Soft Inductive Tactile Sensor Demo

FUTURE CHANGES DOCUMENT

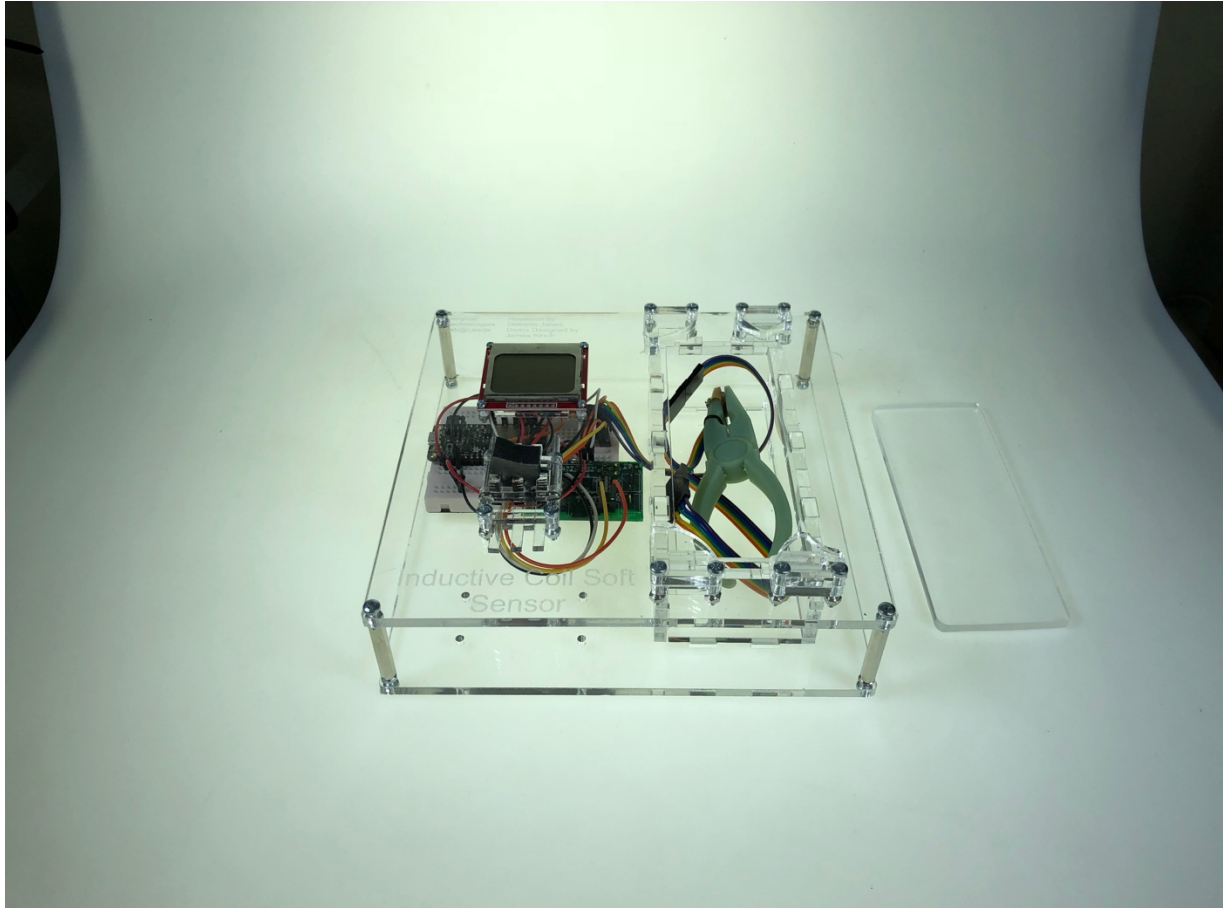
The purpose of this document is to provide a list of the future changes required to be made to the Soft Inductive Tactile Sensor Demo to get it into a fully functional state. As is shown in the image below, there are a number of components that still need to be fitted, as these were unavailable during the original construction of the demo rig.

- 1) **Change demo name etching on the top plate:** the top plate was manufactured before the name of the demo was known and therefore, the name given of 'Inductive Coil Soft Sensor' is no longer correct. This should be replaced with 'Soft Inductive Tactile Sensor'.
